Access Compliance Report

Public Rights-of-Way

(Curb Ramps)

Intersection ID: 17505	Main Street: CRAIG_AV	Cross Street: N_SHARON_AMITY_RD	Location: N
ADA ID: CD7F32D9CF23	Ramp Type: PerpDiag	Initial Pass/Fail: Fail	Overall Compliance: No
		Severity Score: 22.5

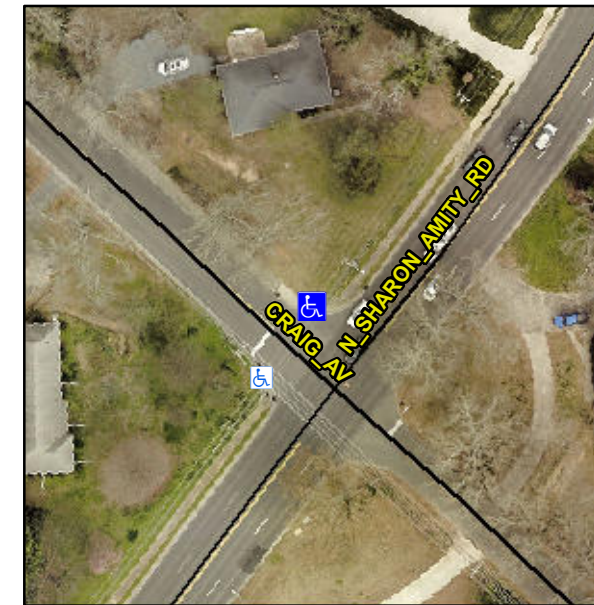
Not Found, R304.5.1, R304.2.2, R304.5.3

Compliance	Description	Data	Compliance	Description	Data
N/A	Ramp Length (in)	59.0	No	Ramp Slope (%)	11.5
No	Ramp Width (in)	39.0	No	Ramp XSlope (%)	4.6
N/A	Flare Type LT	N/A	N/A	Flare Type RT	N/A
N/A	Flare Slope LT (%)	N/A	N/A	Flare Slope RT (%)	N/A
N/A	Flare Traversable LT?	N/A	N/A	Flare Traversable RT?	N/A
N/A	Landing Length (in)	N/A	N/A	DWS Provided?	N/A
N/A	Landing Width (in)	N/A	N/A	DWS Contrast?	N/A
N/A	Landing Slope (%)	N/A	N/A	DWS Length (in)	N/A
N/A	Landing X Slope (%)	N/A	N/A	DWS Full Width?	N/A
N/A	Landing Curb? (Y/N)	N/A	N/A	DWS Offset (in)	N/A
N/A	Shared Landing?	N/A			
N/A	Gutter Ponding?	N/A	N/A	Gutter Slope (%)	N/A
N/A	Gutter Lip Ht (in)	N/A	N/A	Gutter X Slope (%)	N/A
N/A	Painted X Walk1?	No	N/A	Painted X Walk2?	No
	X Walk 1 Direction	To SW		X Walk 2 Direction	To SE
N/A	X Walk 1 Width (in)	N/A	N/A	X Walk 2 Width (in)	N/A
	X Walk 1 Slope (%)	3.4		X Walk 2 Slope (%)	1.4
	X Walk 1 X Slope (%)	2.4		X Walk 2 X Slope (%)	3.2

Remove & Replace Curb Ramp With Two New Directional Ramps or Equivalent.
